**Subject: Geotechnical Consultation
Light Weight Fill Material Recommendations
Alameda Landing Waterfront
Alameda, California
Project No. 731584113**

PROPOSED SEISMIC INSTRUMENTATION PLAN

ALAMEDA LANDING WATERFRONT DEVELOPMENT PHASE

From: Juan Baez **To:** Damir Priskich
Date: October 29th, 2018 **CC:** Haze Rodgers (Langan Associates)
Re: **Response to ECRB Comments re Meeting on Nov 13th, 2018**
Alameda Waterfront Project

**FIGURE 1
INUNDATION ZONES**

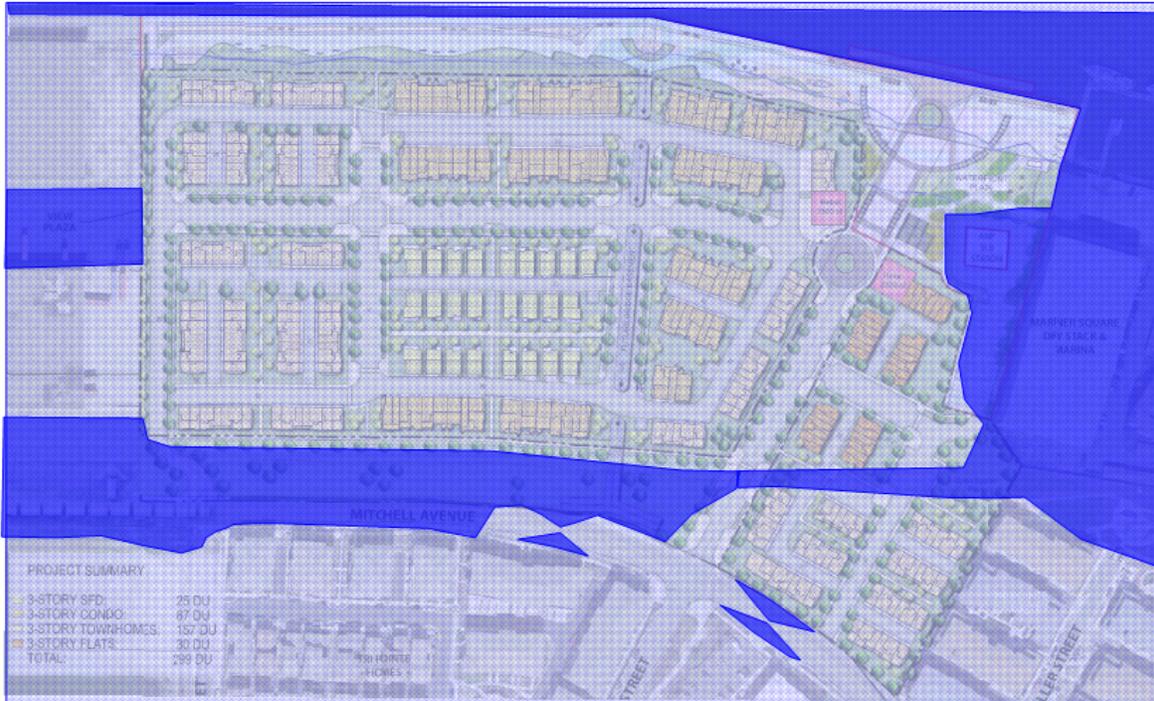
6. Identify sea level inundation zone and associated criteria for Wharf. Determine if Coastal Zone A is appropriate.

Figure 1 (below) indicates the inundation zones that would result from sea levels rising by 1.9-ft and 5.7-ft from current BFE, respectively.

**2050 INUNDATION (ASSUMING 1.9-ft SEA LEVEL RISE ABOVE CURRENT BFE OF 9.75 NAVD 88)**

**2100 INUNDATION (ASSUMING 5.7-ft SEA LEVEL RISE ABOVE CURRENT BFE OF 9.75 NAVD 88)**

Based upon our discussion with staff from the City’s planning and engineering departments, Alameda does not have a policy or guidelines for designing to accommodate climate change, though in March 2014 (prior to the 2018 Report referenced above) they adopted a Master Infrastructure Plan for the neighboring Alameda Point (formerly the Naval Air Station Alameda), which defined infrastructure standards for the redevelopment of the former Military Installation. The policy adopted for Alameda Point requires that new structures be constructed to maintain 1-ft of freeboard to an assumed new Base Flood Elevation assuming 24-inches of Sea Level Rise. Since FEMA does not account for rising tides due to climate change in their FIRM maps, we recommend that the project incorporate the following two-part strategy to mitigate the potential impacts of sea level rise:

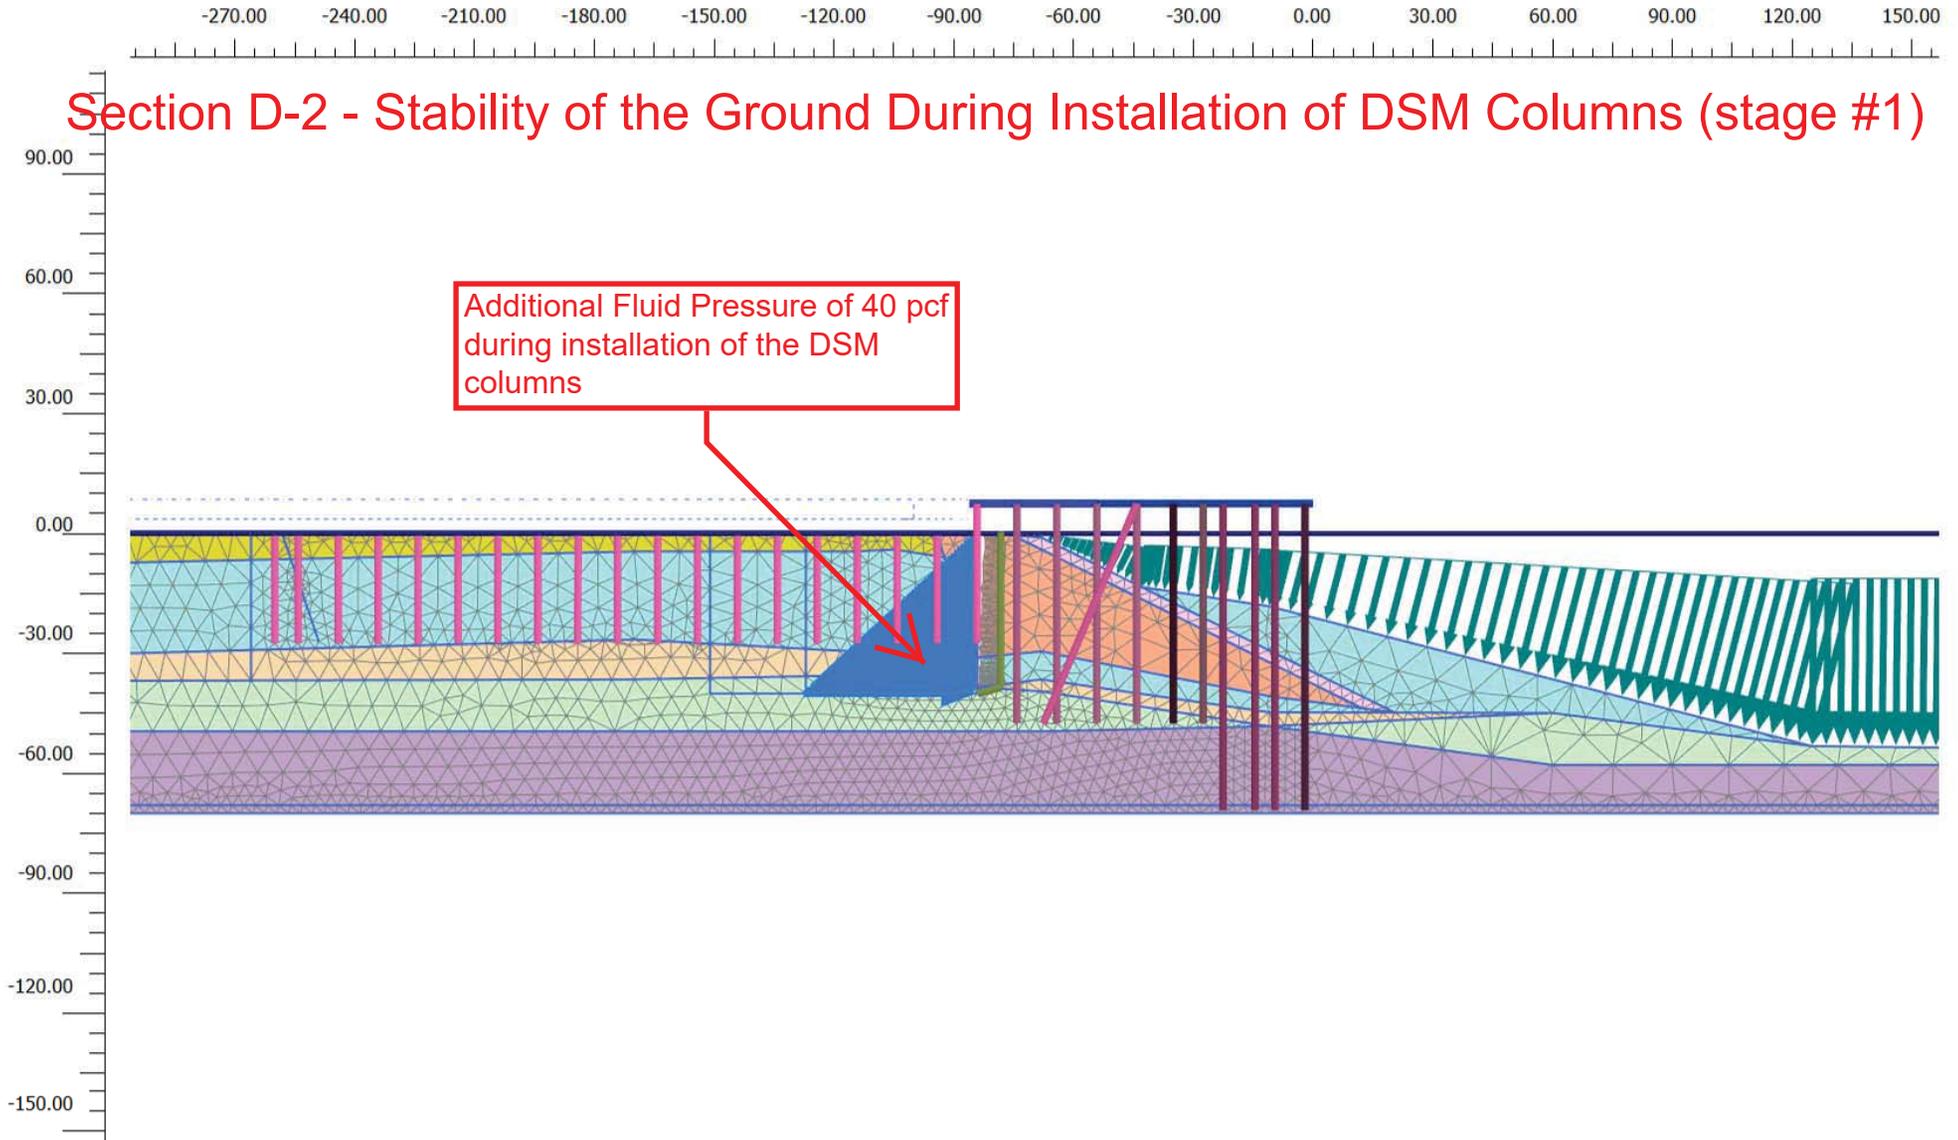
1. The impact of lateral movement of the fill associated with the bay mud, and its impact on the wharf.
6. The ECRB had not seen a plan for the DSM. It is going to be a densified remediation zone to improve the soil response, right next to the wharf. How is it going to be affected by the lateral movement of the bay mud beneath it or close to it, and what is going to be the effect of the lateral movement on the wharf?

The DSM plan and column layout has been previously included in AGI's Design Submittal of September 10th, 2018 (Appendix D –Page 171 of 319). Similarly, the worst case loading condition involving a superposition of Fill, Structural Loads from building pads, and MCE ground motions has been evaluated to assess lateral movements on Bay Mud and displacement magnitude on the wharf foundations. The output of these analyses are included in Appendixes N, O, and P of the referenced AGI design submittal.

We note that, although the referenced loading condition constitutes the anticipated highest loads imparting lateral displacement on Bay Mud and wharf supported piles, the following Table outlines the estimated lateral deformations resulting from the construction stages and application of loads at various times. The attached Appendixes A, and B, depict the Finite Element Plaxis output for the critical cross sections D-2 and F2, respectively, as referenced in the AGI design report.

Loading Case No	Description	Cross Section D-2, Displacement on Bay Mud (inches)	Cross Section D-2, Displacement on Wharf Pile Row J (inches)	Cross Section F-2, Displacement on Bay Mud (inches)	Cross Section F-2, Displacement on Wharf Pile Row J (inches)
1	During DSM Installation from EL +3ft ¹	< 1	< 1	< 1	< 1
2	After placement of Fill from EL +3ft to +8FT	< 1	< 1	< 1	< 1
3	After placement of Building Loads (450 PSF)	< 1	< 1	< 1	< 1
4	After design MCE events ²	12	13	12	13
